# CITY OF ALBUQUERQUE

**RE: Discount Collision**  
**4000 2<sup>nd</sup> St NW**  
**Grading & Drainage Plan**  
**Engineer's Stamp Date: 11/20/2025**  
**Hydrology File: G14D100**  
**Case # HYDR-2025-00415**

Based upon the information provided in your submittal received 11/20/2025, the Grading & Drainage Plan **is not approved** for Building Permit. The following comments need to be addressed for approval of the above referenced project.

<b>DISCOUNT COLLISION</b> 4000 2ND ST. NW <b>GRADING AND DRAINAGE PLAN</b>	DRAWN BY: DEM DATE: 11-19-25 DISCOUNT TOWING, DWG
	Rio Grande Engineering P.O. BOX 53204 ALBUQUERQUE, NM 87199 (505) 321-8099	SHEET # <b>C1</b> JOB #

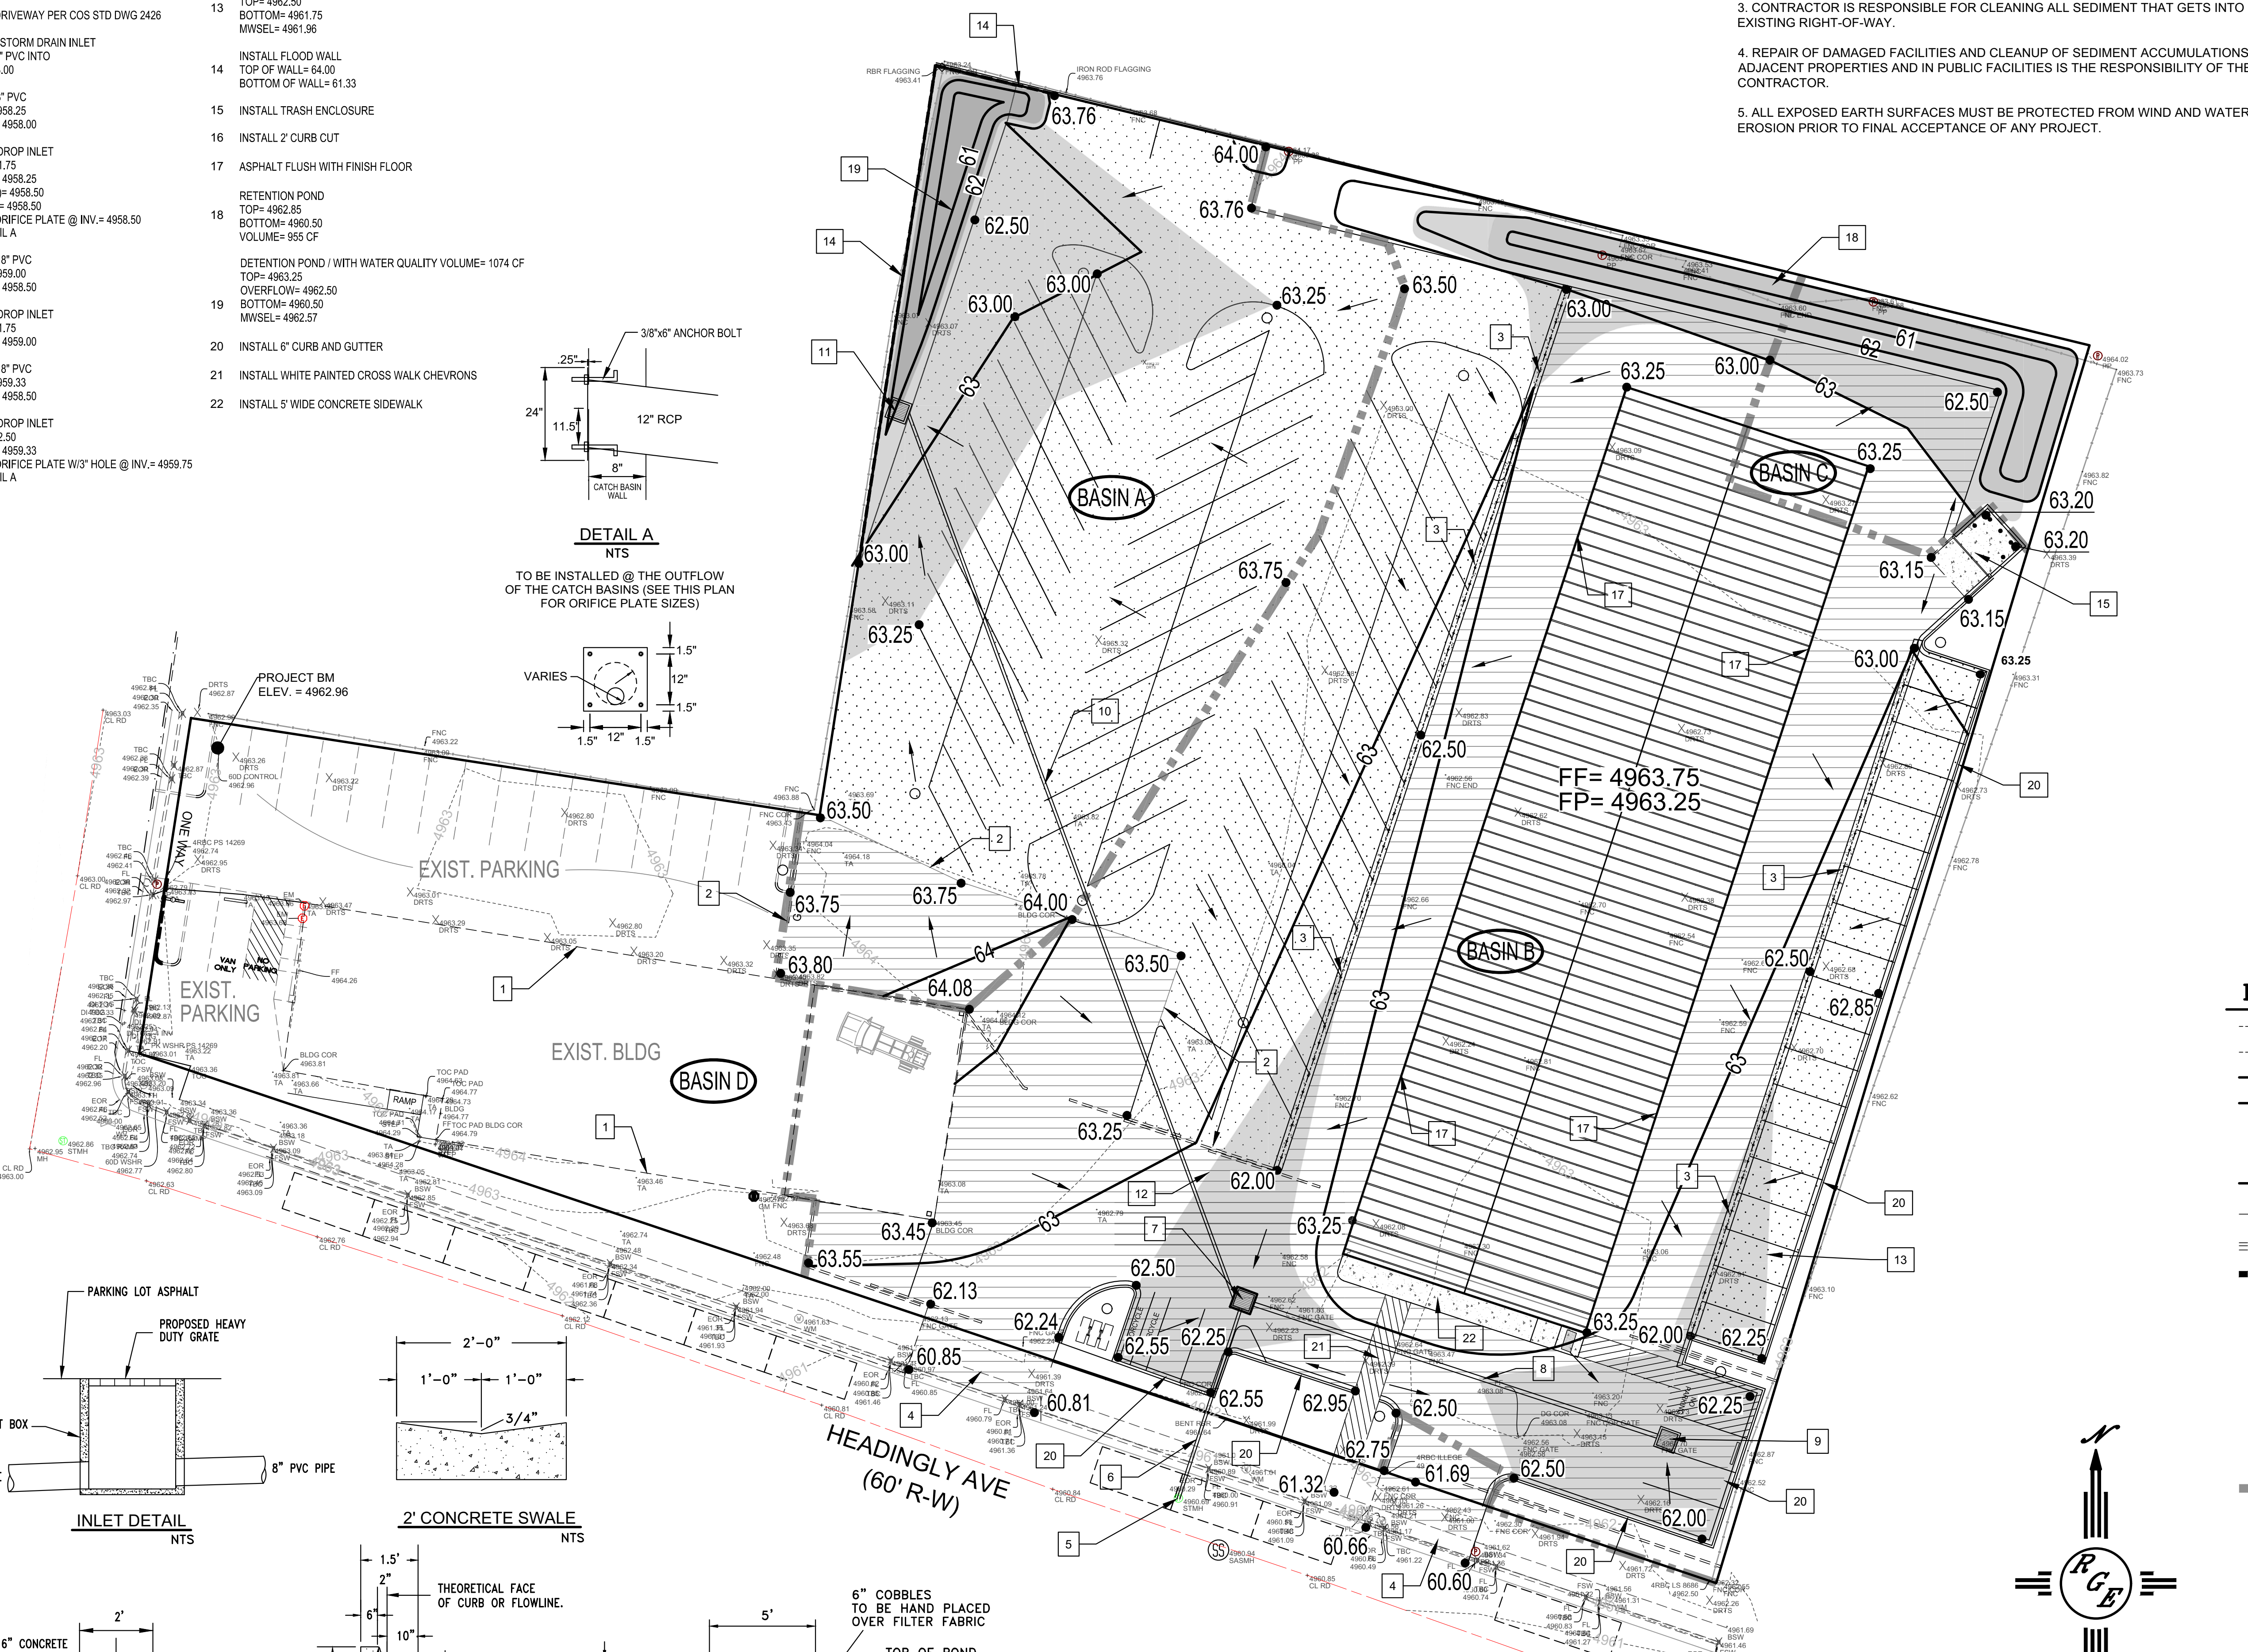
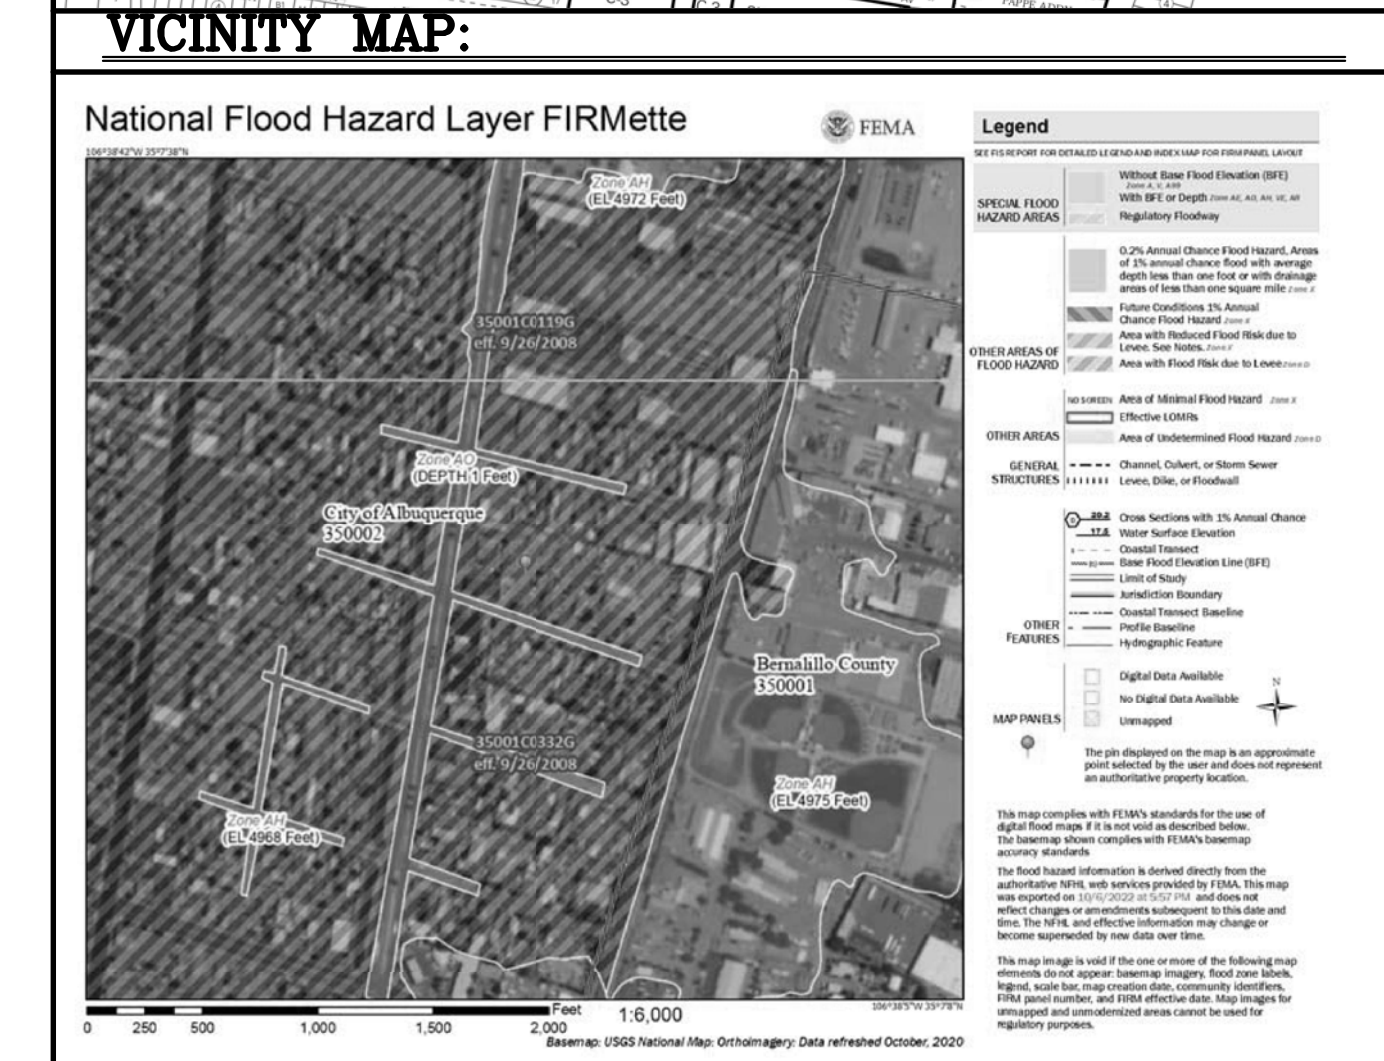
- Please provide the legal description of the property.

- Show the proposed sidewalk along 2<sup>nd</sup> Street NW.
- Please provide the Benchmark information (location, description and elevation) for the survey contour information provided.
- Please provide the FIRM Map and floodplain note with effective date.
- Show the limits of the SFHA Zone AO (1') on the plan.
- Since this site is in the Valley region, please follow Article 6-5 Valley Drainage Criteria of the DPM. The following conditions must be applied to the site:
  - Pad elevation shall be a minimum of one (1) foot above the 100 year 10-day stormwater surface elevation.
  - A permanent perimeter wall or barrier around the development is required to contain the 100 year 24 hour storm developed runoff.

8. Provide inlet calculations, including 2x capacity (50% clogging factor) for inlets in a sump.
9. Verify if a waterblock, 0.87' high, per COA Paving Detail No. 2426, at the driveway entrance will be needed due to the SFHA Zone AO(1').
10. Add note on the plan that "No work shall be performed in the public ROW without an approved Work Order or Excavation Permit".
